CERTIFICATE OF APPROPRIATENESS

Property: 8734 Glenloch Drive, Lot 4, Block 52, Glenbrook Valley Section 9 Subdivision. The property includes a historic 2,282 square foot, one-story brick veneer single-family residence with attached garage situated on a 9,040 square foot (80' x 113') corner lot.

Proposal: Alteration – In July 2014 the applicant replaced 14 original aluminum single lite fixed windows, 2-part and 3-part single lite slider windows with 11, 9-lite slider, 6-over-6 sash windows, and a 3-part bay window, replaced the front entry door with a 9-lite front entry door, installed inoperable shutters, and replace the sectional overhead garage door with a new garage door without a City Permit or Certificate of Appropriateness.

Recommendation: Approval with conditions:

NORTH SIDE ELEVATION
ORIGINAL CONDITON

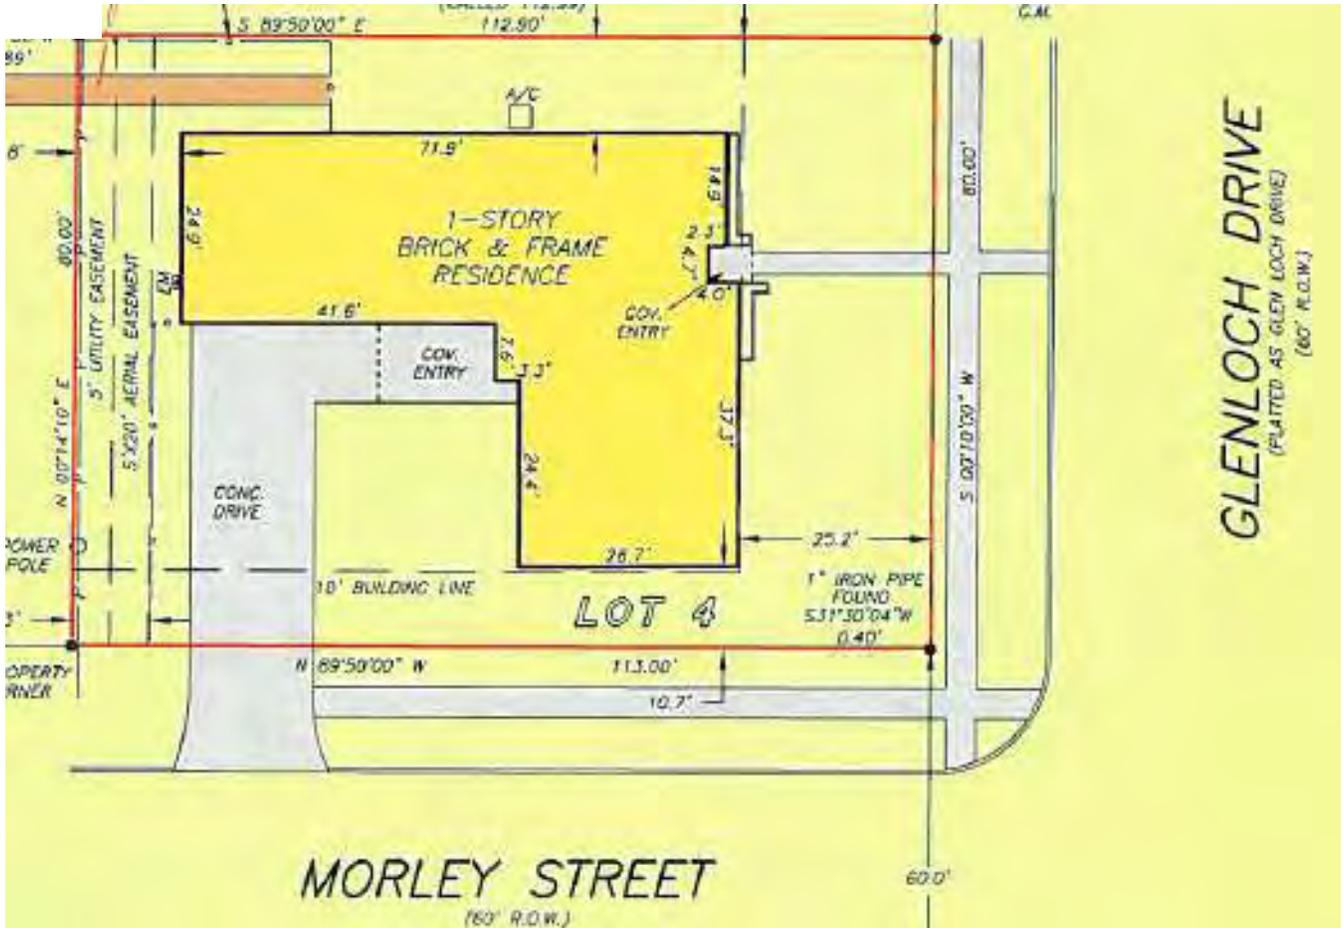
<i>The removal of the original single lite windows and solid entry door results in the significant loss of historic materials. The new divided lite windows with shutters along with the installation of the bay window introduce new architectural features and are not compatible with the historic character of the 1959 Traditional Ranch.</i> |

Windows/Doors: The residence featured 14 aluminum three and 2-part slider windows and single lite fixed windows, and a solid entry door. In July 2014 the original aluminum windows were replaced with 11 vinyl 9-lite slider, and sash windows. Three single lite windows were replaced with a three part bay window with 9-lite vinyl windows. The window openings were not modified. The solid front entry door was replaced with a 9-lite front entry door. The sectional overhead garage door was replaced with a new sectional overhead garage door.

Side Elevation: Two 3-part slider windows were replaced with two 3-part 9-lite slider windows; a 2-lite slider window was replaced with a 2-part 9-lite slider window.

Replace the existing 9-lite slider and sash windows with single- lite slider windows and 1-over-1 sash windows, remove the bay window and install 3, single lite windows to match the original condition and remove the inoperable shutters.
